SERVICE BULLETIN

Service Bulletin No. 529B
(Supersedes Service Bulletin No. 529A)
Engineering Aspects are
FAA Approved

SUBJECT: Reprint of Crane/Lear Romec Service Bulletin No. 101SB020, Rev. 3

FUEL PUMP – Torquing of Relief Valve Cover Screws.

Torquing Sequence – RG17980 Series
Figure 1

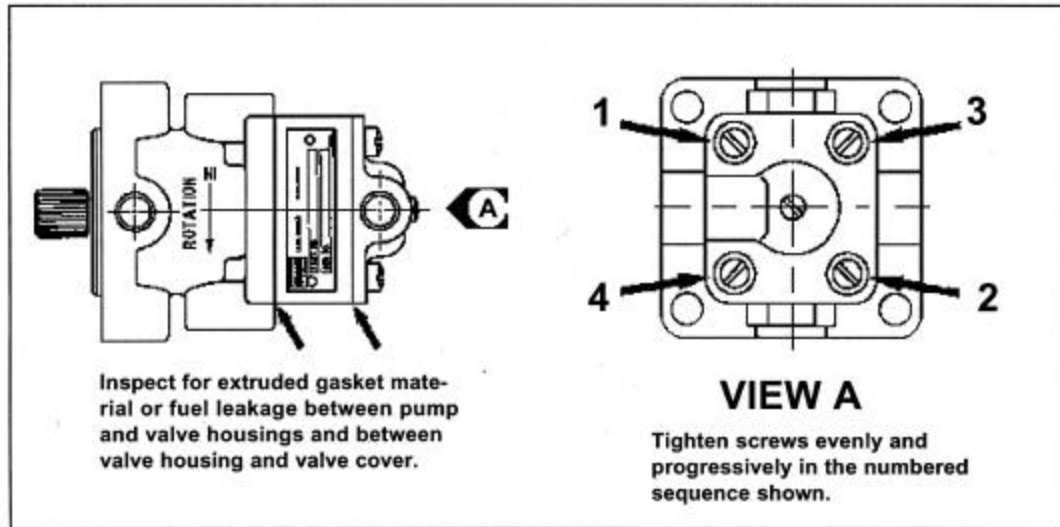
- (a) If pump is accessible without removing it from aircraft, the following check shall be performed.
- (b) Visually inspect the split lines between the pump housing, relief valve housing and relief valve cover for evidence of fuel leakage or noticeable gasket extrusion adjacent to the pump inlet and outlet ports. If there is evidence of fuel leakage or noticeable extrusion, replace the pump per applicable engine maintenance instructions. (See figures 1,2,3 & 4.)
- (c) Check the tightness of relief valve cover attaching screws using a torque indicating screwdriver. Minimum torque shall be 23 inch-pounds. Torque shall be checked in the tightening direction.
- (d) If screws are loose, remove safety-wire and tighten screws evenly and progressively in a criss-cross pattern to 23-25 inch-pounds torque in the sequence shown in figures 1 and 2.

- (c) If screws are loose, tighten screws evenly and progressively in a criss-cross pattern to 23-25 inch-pounds torque in the sequence shown in figures 1 and 2.

Normal Extrusion – All Series
Figure 3

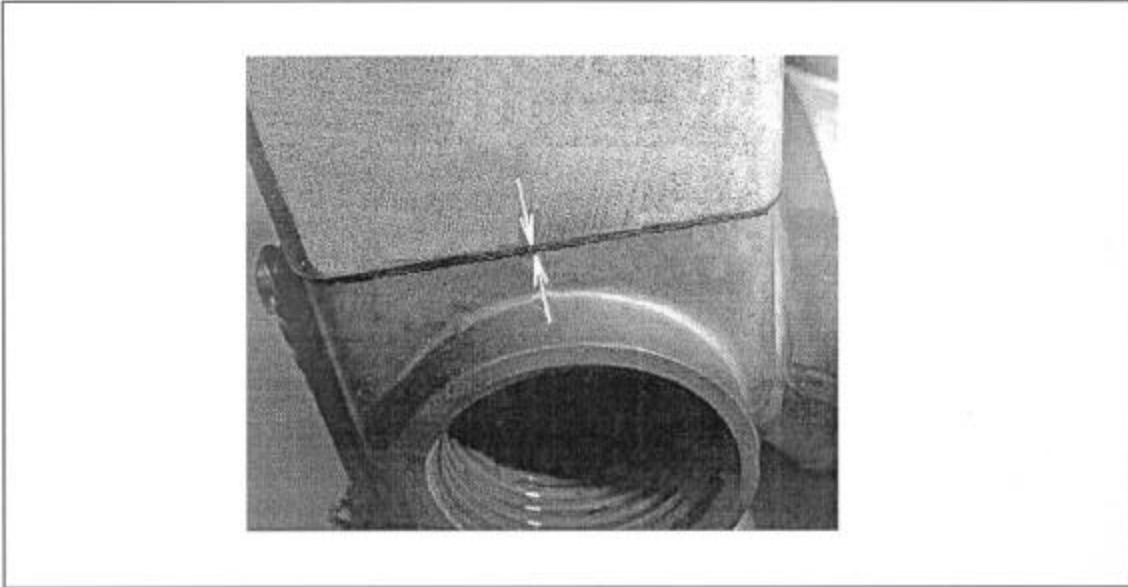
- (a) Visually inspect the split lines between the pump housing, relief valve housing and relief valve cover for evidence of fuel leakage or noticeable gasket extrusion adjacent to the pump inlet and outlet ports. If there is evidence of fuel leakage or noticeable extrusion, replace the pump per applicable engine maintenance instructions. (See figures 1,2,3 & 4.)
- (b) Check the tightness of relief valve cover attaching screws using a torque indicating screwdriver. Minimum torque shall be 23 inch-pounds. Torque shall be checked in the tightening direction.
